PREVOST

**WARRANTY
BULLETIN**

WB14-27

DATE :	APRIL 2014	SECTION :	18 - Body
EXPIRATION:	APRIL 2016		
SUBJECT :	CABLE INTERFERENCE WITH REAR DRIVE AXLE TRIPOD

Figure 1

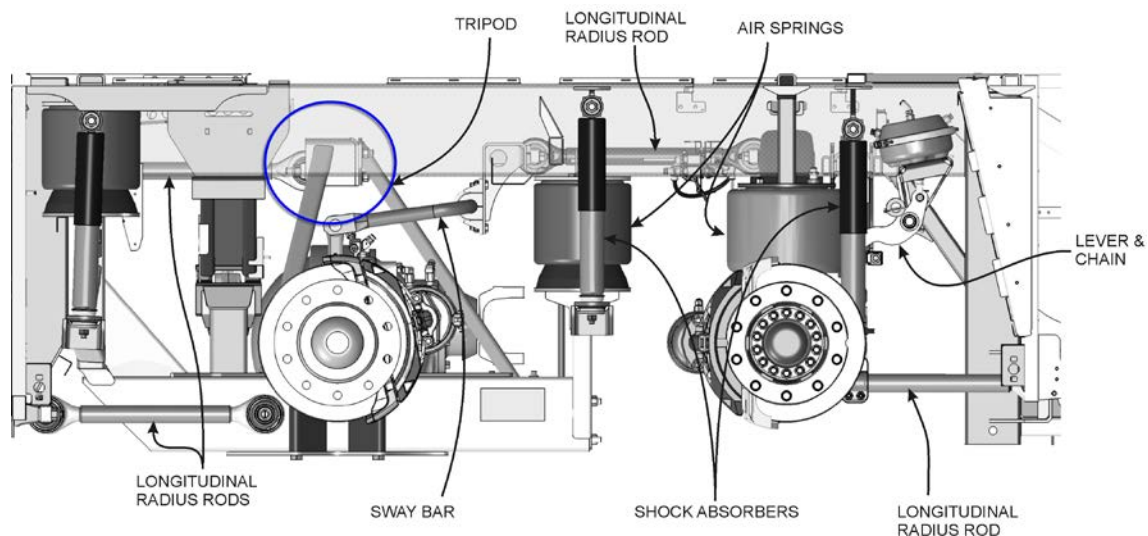
1. Deflate suspension air springs.
2. Lift vehicle using mobile column lifts. Make sure you are lifting the rear end by the drive axle.
3. Locate tripod above the drive axle. The tripod is a triangular arrangement of tubing with an anchor point for a radius rod.

Figure 3 Front looking towards back

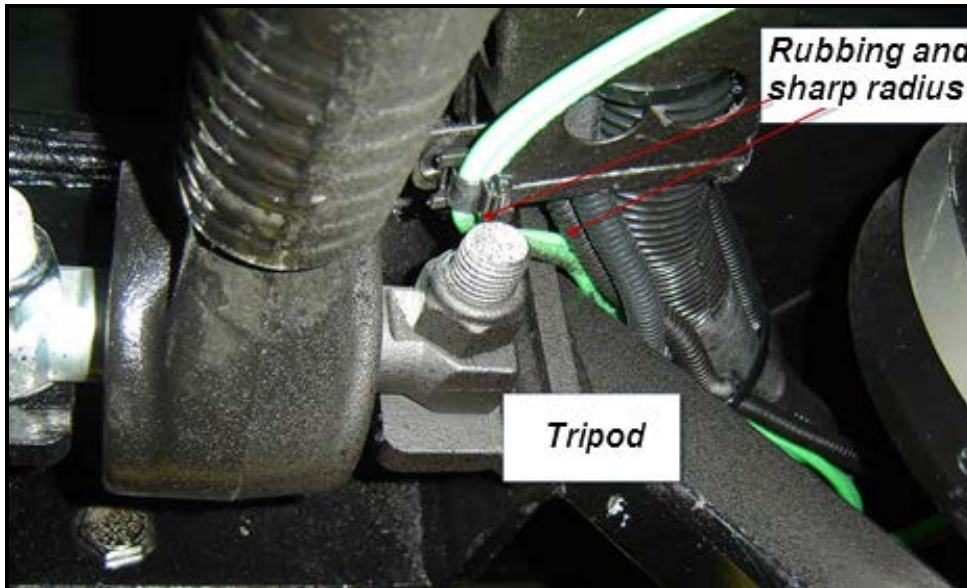
4. There may be an interference with the cables and tubes in this area, similar to figures 2, 3 and 4.

5. If there is contact, move cables above or below large corrugated tube and away from interference zone.
